# Manual Revisions PJM EMS Upgrade Manual Documentation

Adamy Garcia – EMS Technologies Becky Davis – NERC Compliance Operating Committee February 9, 2023

# NERC Certification & Manual Revisions

- Three Manuals will be revised to remove specific EMS vendor information:
  - Manual-01 Control Center and Data Exchange Requirements
  - Manual-13 Emergency Operations
  - Manual-36 System Restoration

#### 3.1.7 PJM Assumes Balancing Authority Role

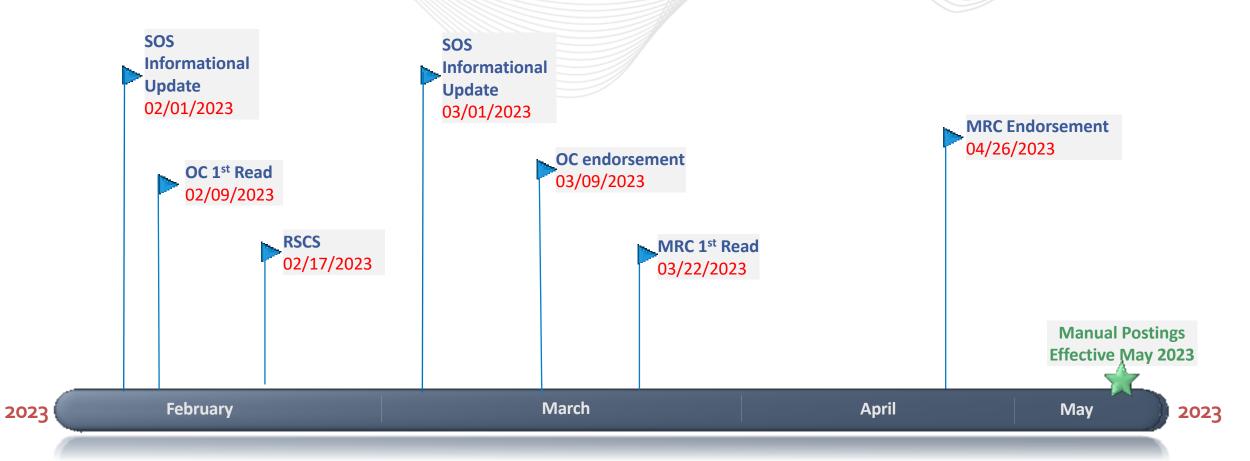
The PJM EMS has the capability of calculating and monitoring ACE for up to five-ten internal islanded areas or subsystems connected to the Eastern Interconnection. This assumes that PJM has sufficient monitoring in these subsystems (including frequency monitoring and tie line monitoring). Once PJM verifies accurate data and ACE calculation within a subsystem, PJM will coordinate with the Transmission Owners within the subsystem and when appropriate resume

Changed from five to ten
